RE: MINOR CHANGE TO EXISTING APPROVAL UPON LAND AT 6 JOSLING STREET & 73 BRISBANE STREET, TOOWONG QLD 4066

We write in relation to the abovementioned application and Council's Further Advice email dated 15 July 2026 and provide the following response.

Figure 1: CAD drawing demonstrating relocated bollard and location of bin between rear of RCV and speed hump

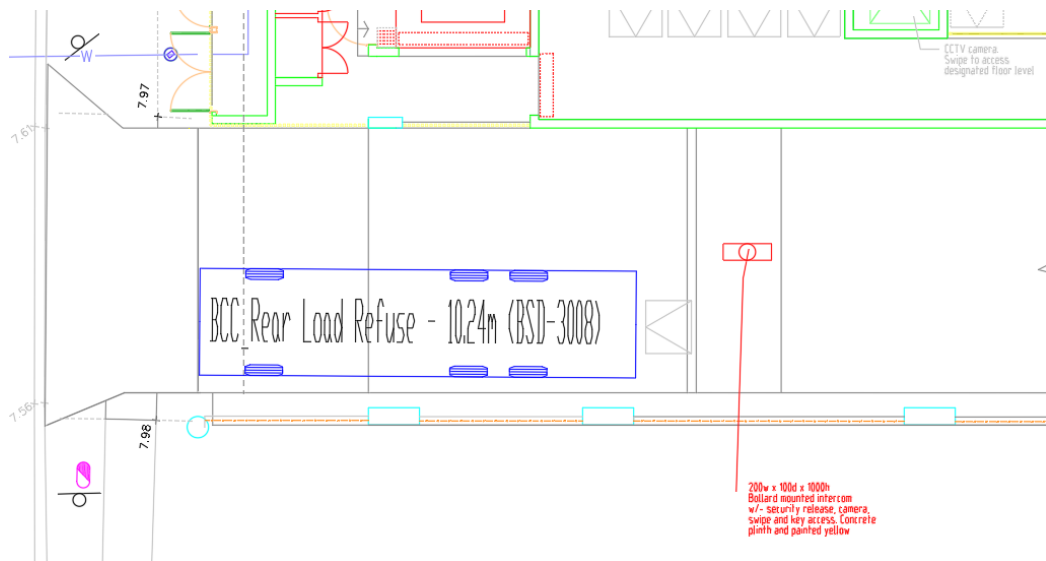
1. *The proposed bollard-mounted security intercom near the entrance to the car park appears to be directly within the bin transfer path.*
 - a) *Relocate the bollard-mounted security intercom feature so that it does not interfere with the bin transfer path to the rear of the RCV loading area*

- a) *Demonstrate on amended plans the dimensions of the Bin Collection and Bin Refuse rooms.*
-
1. The proposed bollard-mounted intercom for access to the basement car park has been relocated to the lower side of the speed hump. This amendment enables bins to be transferred from the bin collection room to the rear of the RCV without obstruction from the bollard. This also allows bins to remain in front of the speed hump at all times during the transfer, to ensure bins do not roll away as demonstrated in Figure 1. Refer to the enclosed updated Ground Floor (Level 1) Plan prepared by LABVL Design.
